Malek Fahd Islamic School	MFIS		Elevation & Sections		1502413 27864 DA202	
612 Macdonell Park Rd, Liverpool

Development Application DA-1251/2012 – Islamic School Hoxton Park

**PROPOSED EDUCATION ESTABLISHMENT WITH ASSOCIATED CAR PARKING
AND LANDSCAPING
AT 210 PACIFIC PALMS CIRCUIT, HOXTON PARK**

I refer to our discussion about the Objections Council has received to the development application for the Malek Fahd Hoxton Park School and I set out below the Objection and the Applicants response to each of the main Objections. The Response has been prepared by the experts involved, including the Engineer, Architect, Acoustic Engineer, Planner and School Principal.

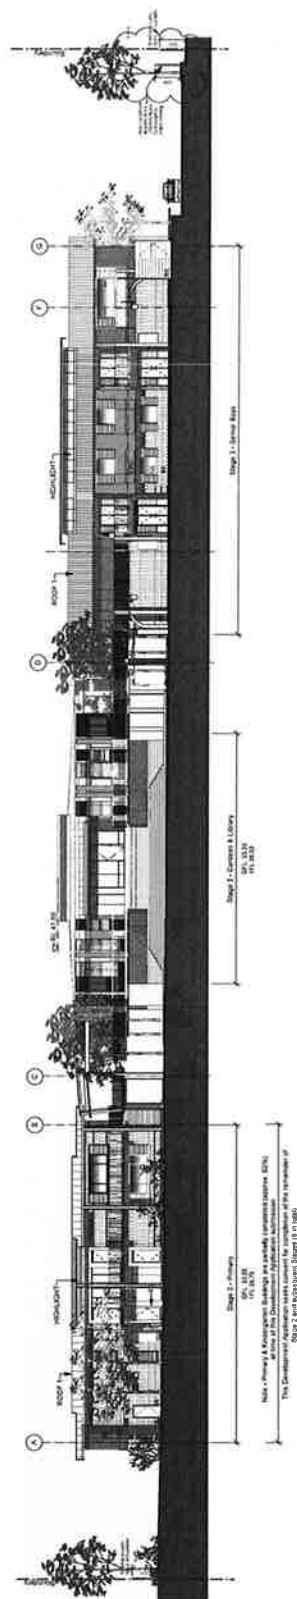
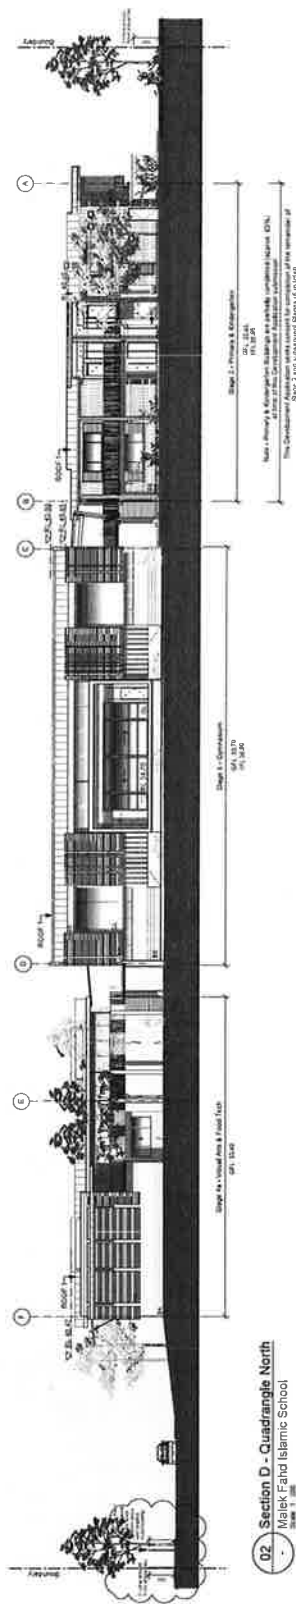
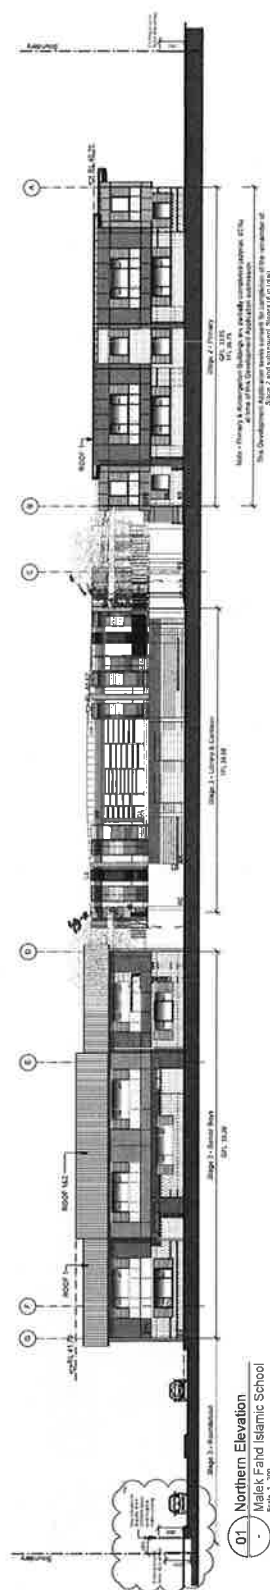
In this case the development standard relates to the height of a building in the plans for a school on the subject site at 612 Hoxton Park Road. The proposed building is a gymnasium and performing arts building that requires a high floor to ceiling dimension. It is located in the centre of the site. Although the ground level at the location is above the 1 in 100 flood level it is below the projected pmf level and under Council's policy the site has to be filled to the pmf level. Hence the particular building exceeds the height limit of 8.5 metres above the natural ground level.

Maximum height of any building is 8.5M above existing ground line in accordance with LEP with reference to Architectural Drawing No's DA201 Rev.C & DA202 Rev.C: with the exception of the centrally located Gymnasium & Performing Arts Building all buildings do not exceed an 8.5M height limit above amended/proposed ground lines. The Gymnasium & Performing Arts exceeds the height limitation by about 800mm in part.

We wish to bring to Councils attention that the Building Height Conditions above existing ground line have been exacerbated by a requirement for buildings and site to be filled/located above the Probable Maximum Flood Level as confirmed by our Civil Works Consultant with Council and with reference to the Cabramatta Floodplain Management Study. In part, studies indicate that nearly 2.0 metres of fill on the existing ground will be required on the site of the Gymnasium & Performing Arts Building to elevate it to required levels.

The building has been designed to provide a '*clear of obstructions*' internal height of 7M in accordance with The NSW Dept. of Education's – Secondary School Facilities Standards. To this end and allowing for the economics of structure the building is designed to be no higher than is absolutely necessary.

The subject building has been sited centrally & nestled amongst complying two storey facilities, courtyards & landscaped areas in order to modulate any sense of the buildings mass and height. i.e the Gymnasium & Performing Arts Building is not a stand alone building and surrounding covered walkway linkages and buildings have been placed to sensitively conceal those higher parts of the building. Additionally and due to its siting there are no issues of overshadowing of residential properties. Refer DA501 Rev.B & DA502 Rev.B.

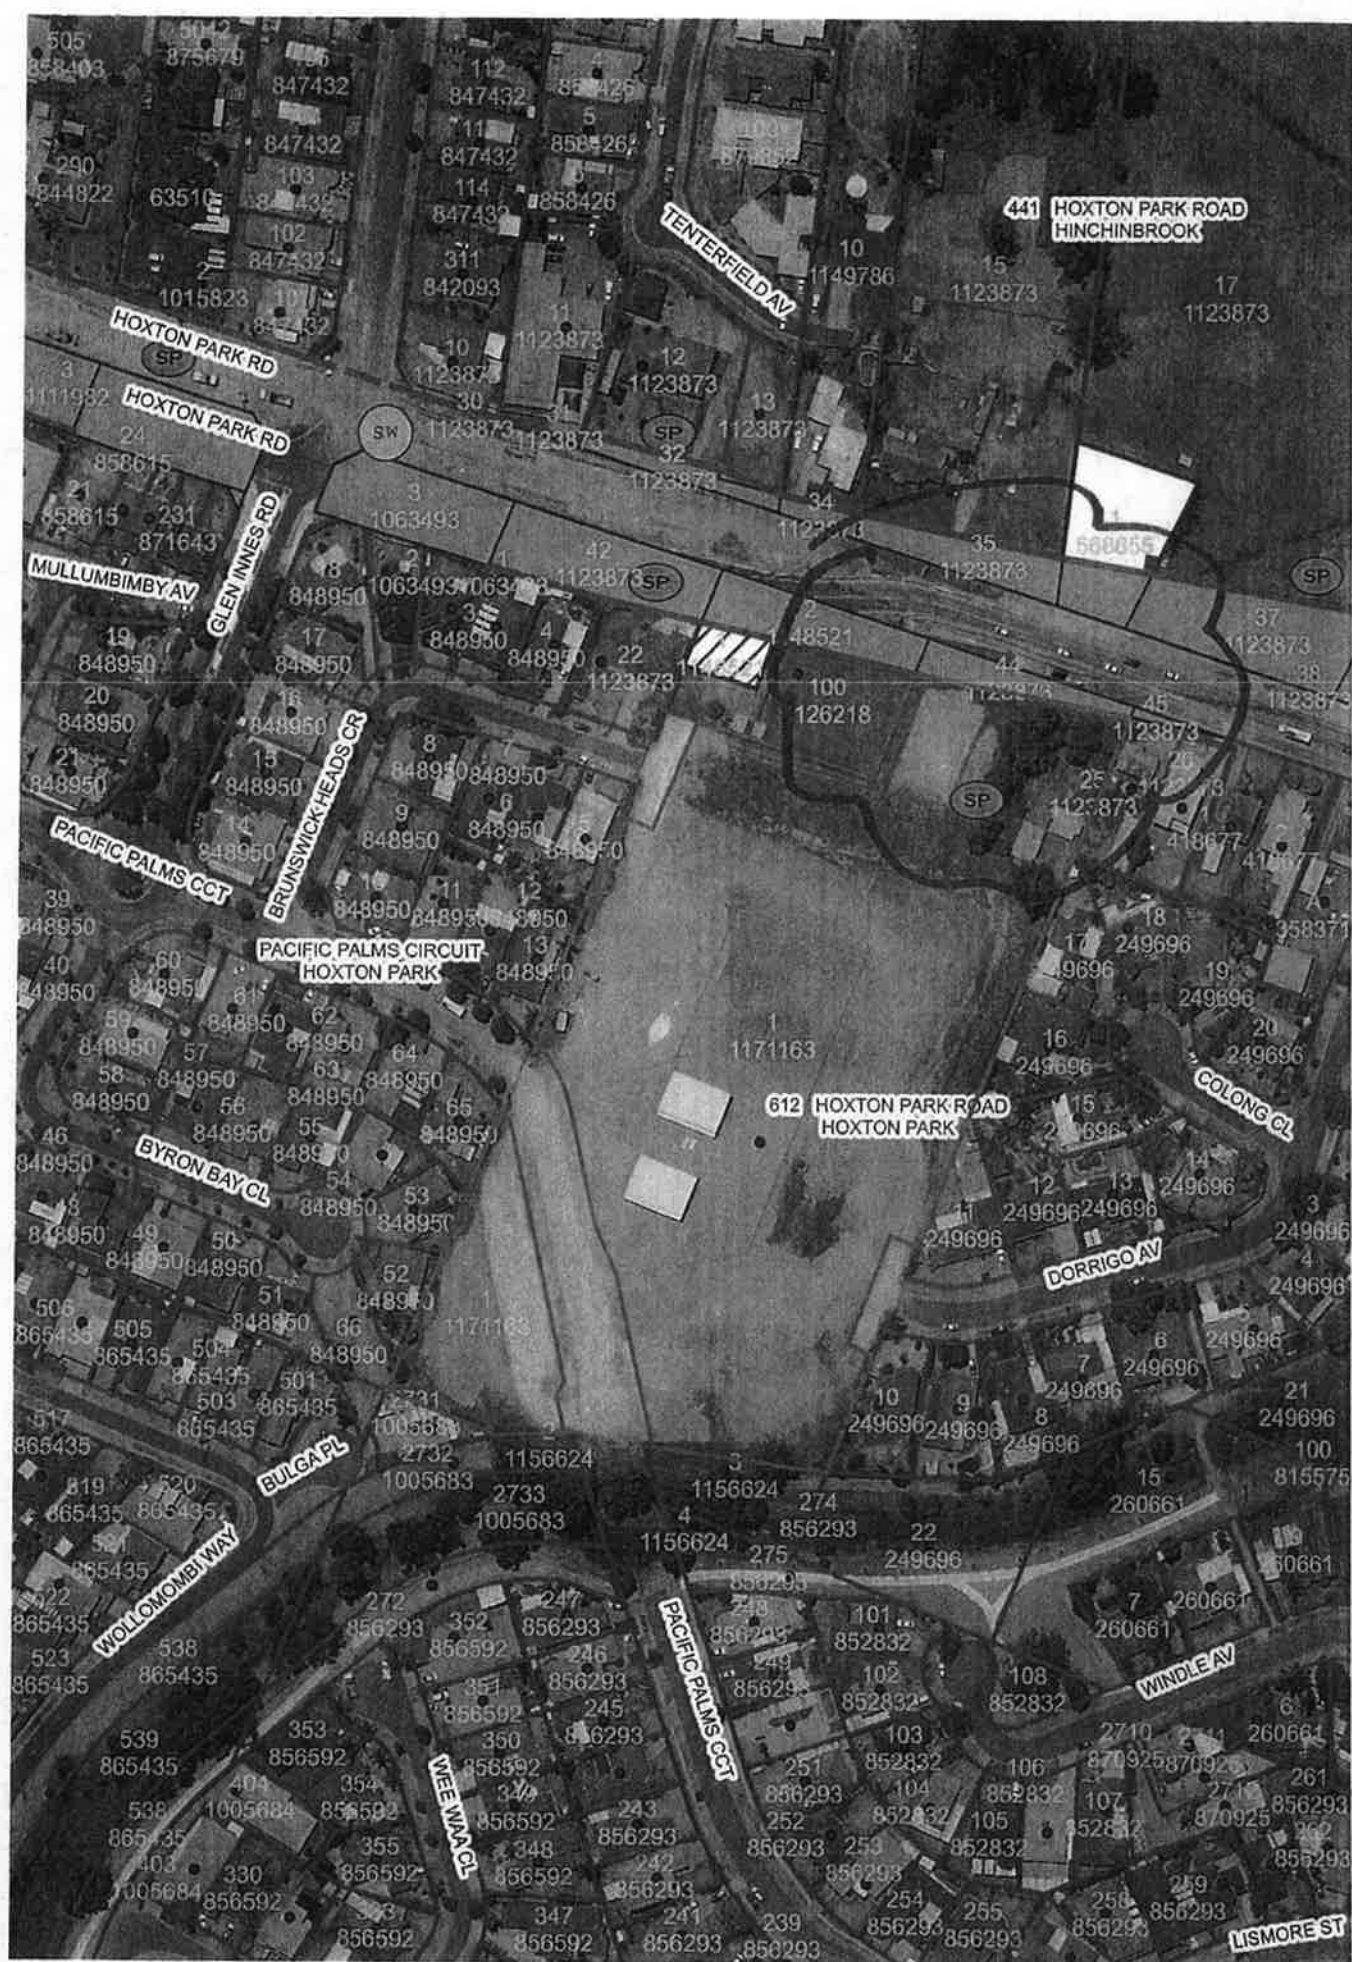
1. RMS has previously acquired a strip of land for road along the Hoxton Park Road frontage of the subject property (Lot 44 DP 1123873), as shown by blue colour on the attached plan. In this regard, any new buildings or structures shall be erected clear of the land acquired for road.
2. No access (including pedestrian access) is to be gained from Hoxton Park Road, Dorrigo Avenue and Brunswick Heads Crescent.
3. The details of the vehicle occupancy rate for students attending the school as well as the mode split to school buses (mini buses) should be provided to Council's satisfaction.
